RADIOLOGICAL EFFLUENT TECHNICAL SPECIFICATIONS
(RETS) IMPLEMENTATION - COOPER NUCLEAR STATION

EGG-PBS-6612

Published May 1984

ABSTRACT

Figure 1. Liquid Radwaste System and Effluent Pathways

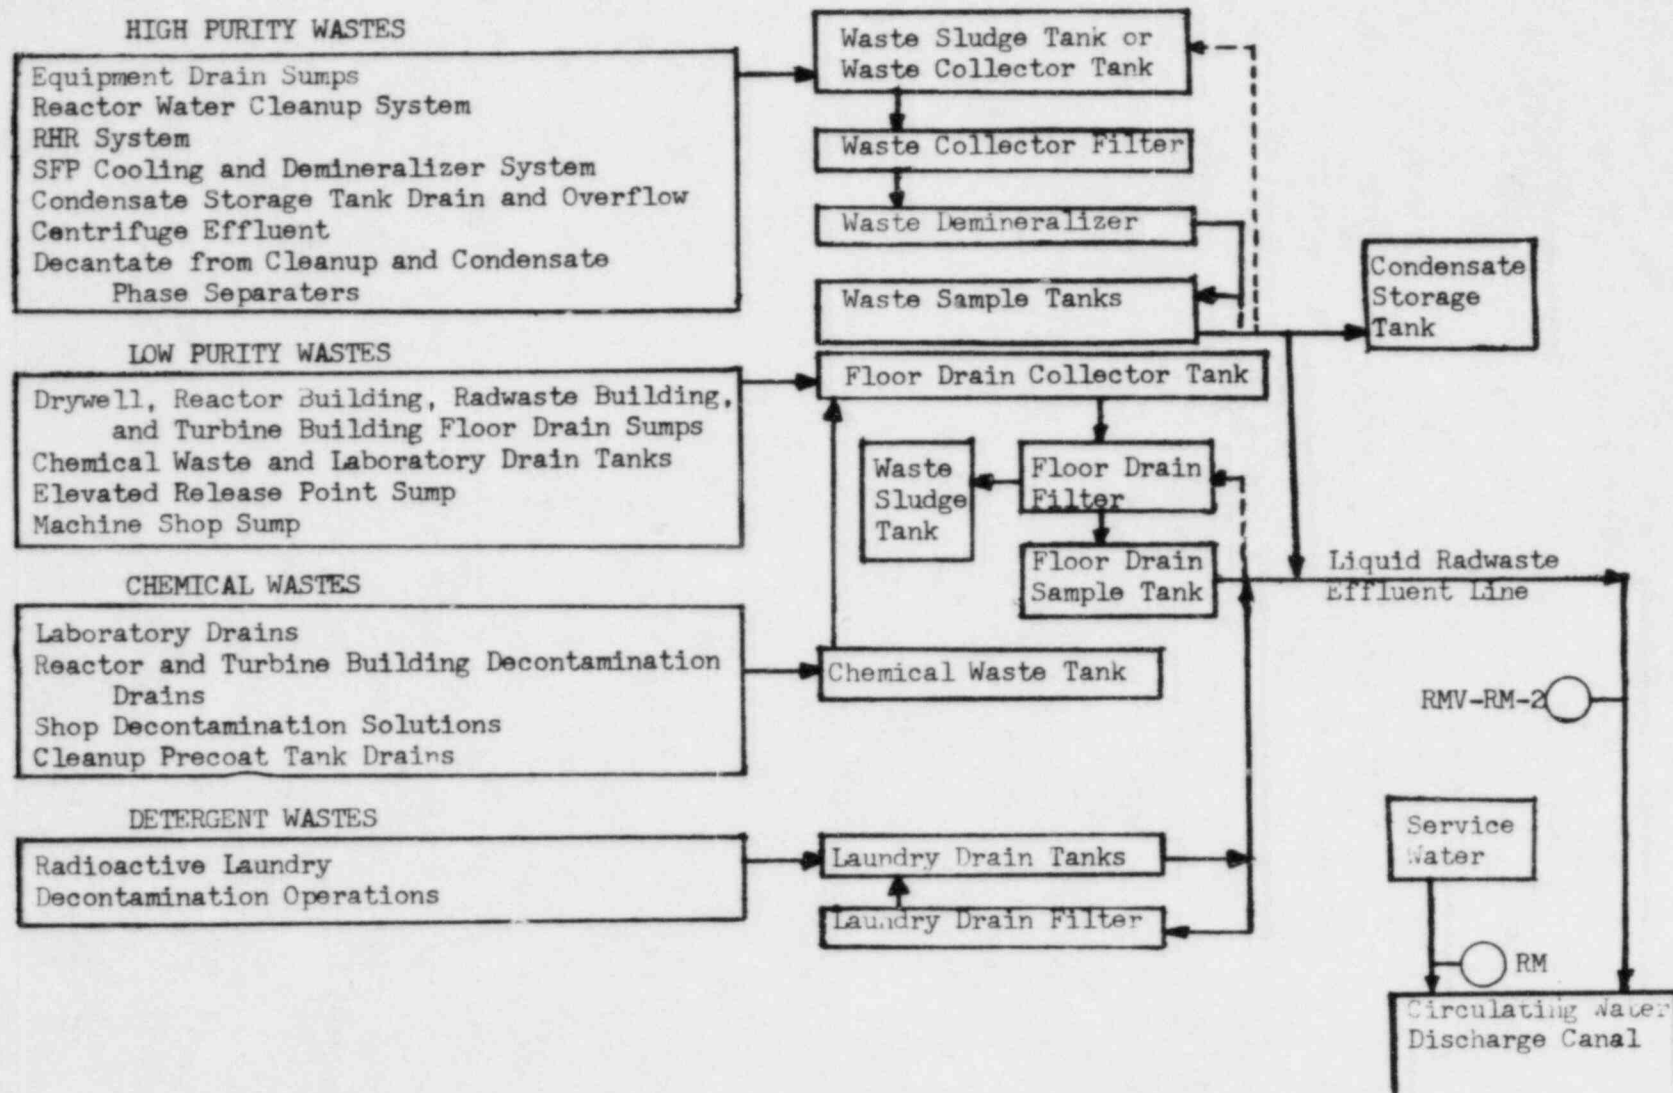
As shown in Figure 1, there are two radioactive liquid effluent release paths to the circulating water discharge canal: the liquid radwaste effluent line and the service water system. The liquid radwaste effluent line is the common release line for potentially radioactive liquids from the waste sample tanks, floor drain sample tank, and the laundry drain tank. All releases from these systems are by batch mode. Sampling and analysis is performed prior to discharge to ensure 10 CFR 20 limits are not exceeded, and all releases are monitored at the radwaste effluent line. Water that may be contaminated with radioactive material is either reused or discharged to the Missouri River after dilution in the circulating water discharge canal.

Instrumentation surveillance being performed. The locations of the monitors are shown in Figure 1.

Specific parameters of distance and the direction of locations of all sampling stations for the environmental monitoring program are provided in the Table and Figure C-2 of Appendix C to the ODAM. The ODAM also contains maps showing the unrestricted area boundary and the location of the elevated release point and the discharge canal. A simplified diagram of the gaseous effluent streams, treatment and monitoring equipment, and discharge points is included as Figure 3-1 in the ODAM. No comparable diagram is included for the liquid radwaste system.

Figure 2. Gaseous Radwaste System and Effluent Pathways

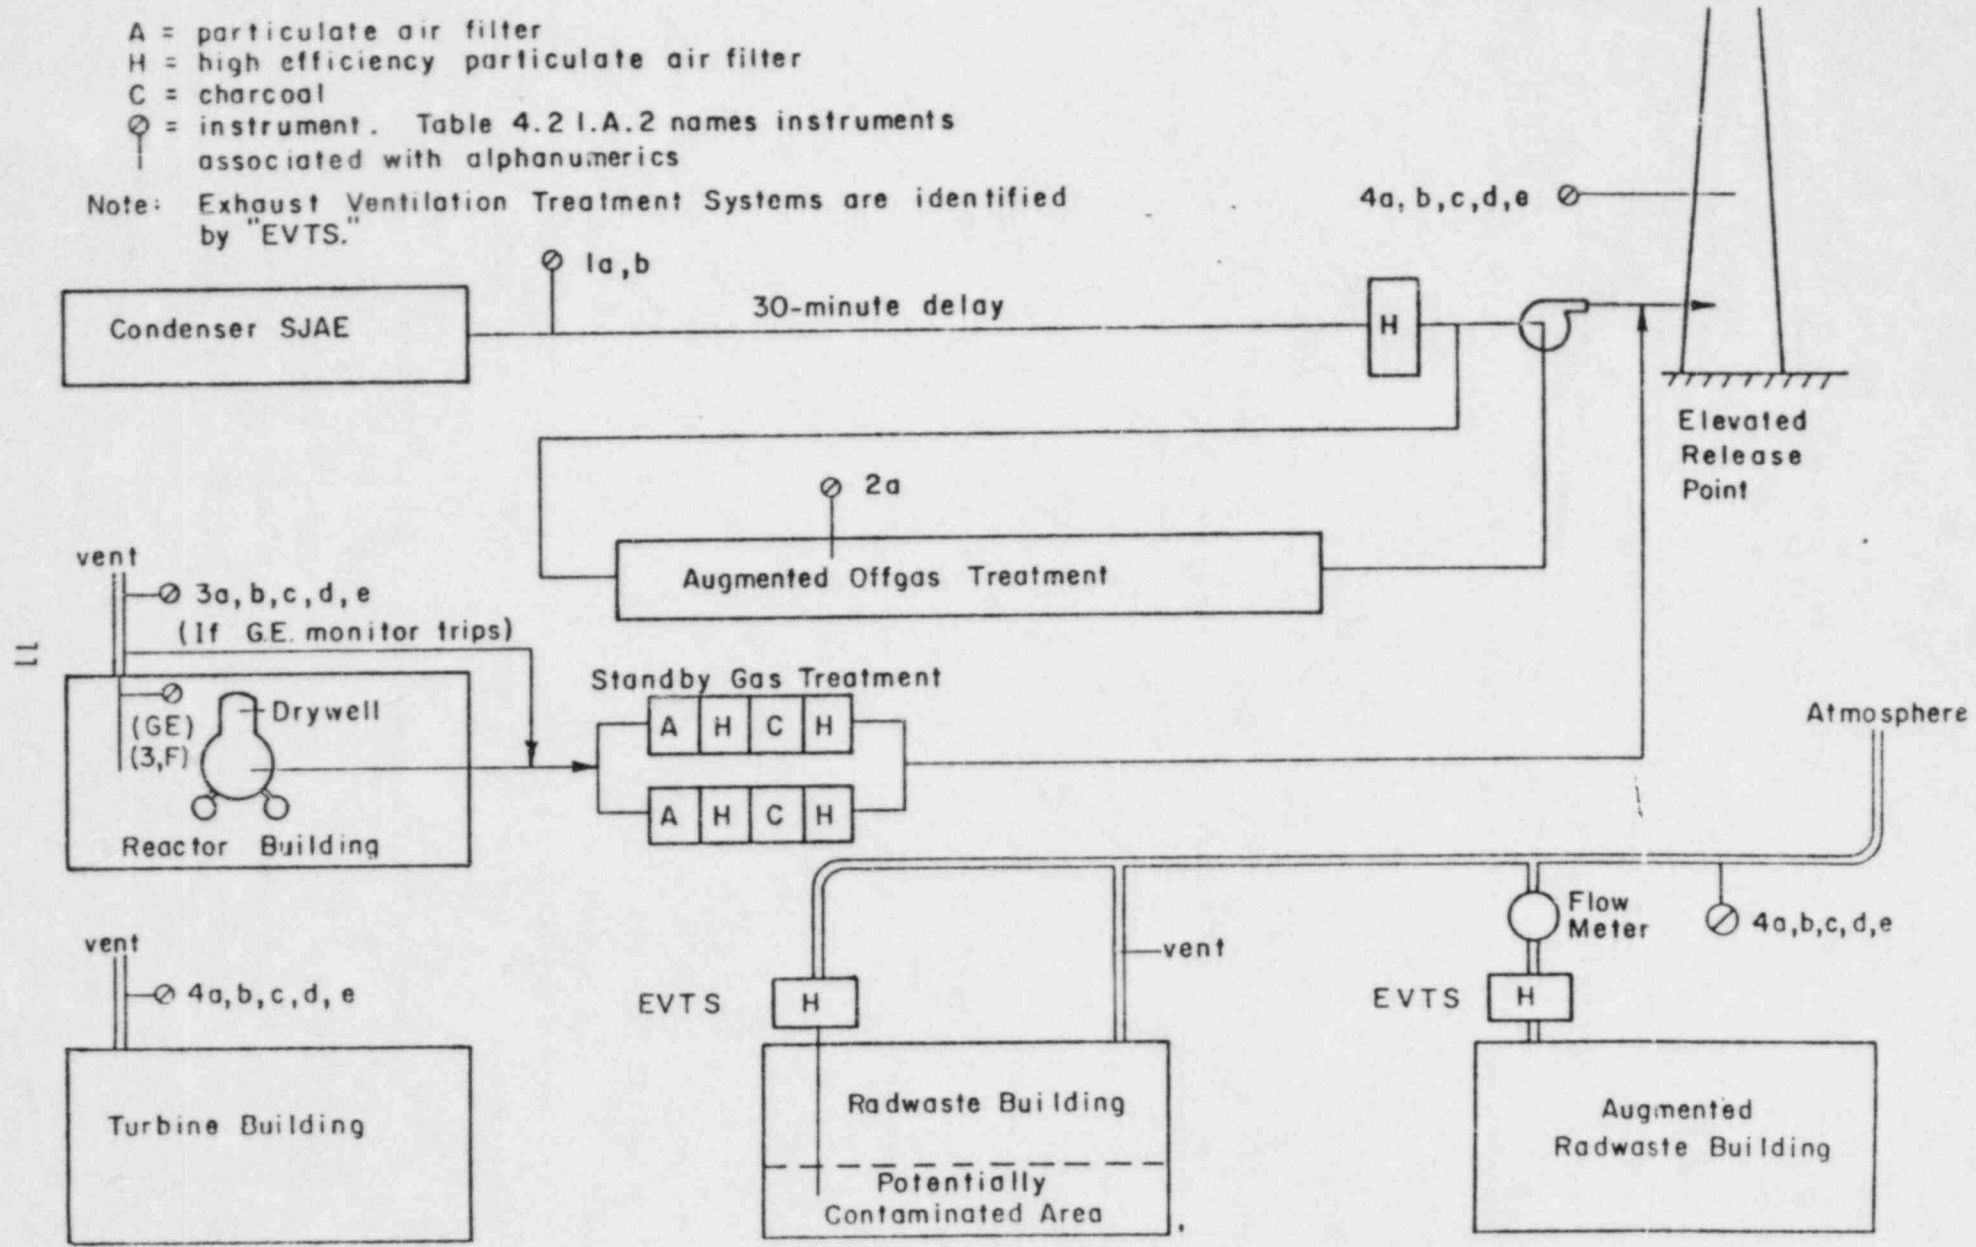
As shown in Figure 2 there are four radioactive gaseous effluent release points at the CNS. They are (a) elevated release point (ERP), (b) the reactor building vent, (c) the turbine building vent, and (d) the radwaste building vent. The sources of radioactive gases, the treatment given the gases, and their paths to the release points are outlined in Figure 2.
